**APTB 06/13**

**SUBJECT: G2.8 Connector Dust Seal**

**Technical Bulletin**

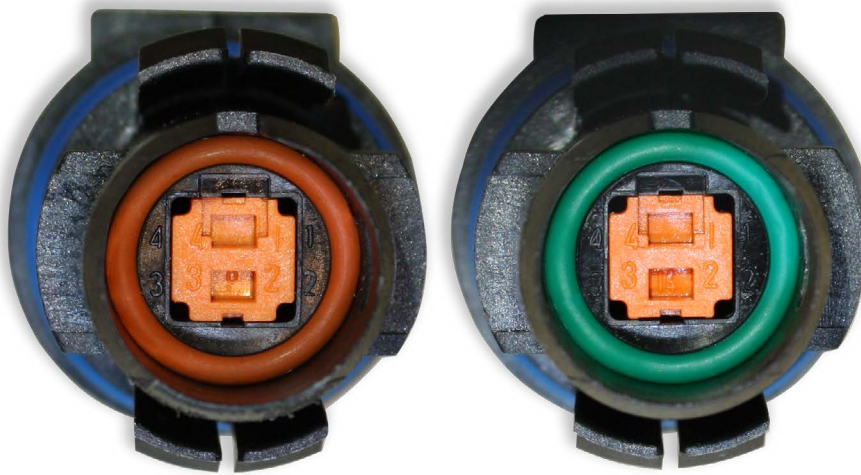
Occasionally, Alliant Power is forced to replace the electrical connector on G2.8 Injectors due to wear or damage. These new connectors are received by Alliant Power complete with the internal and external seals already installed. There is one visible difference with the new connectors that are used during the remanufacturing process, the internal dust seal.

The seal used by Alliant Power, in both the remanufacturing process as well as the **AP0002** G2.8 Injector Seal Kit, is orange in color. The seal supplied with new connectors is green in color.

While the color of the seal is different, the reliability of the seal is consistent and will not affect the performance of the injector or the integrity of the electrical connection. The two types of seals may also be intermixed on an engine with no influence on performance.
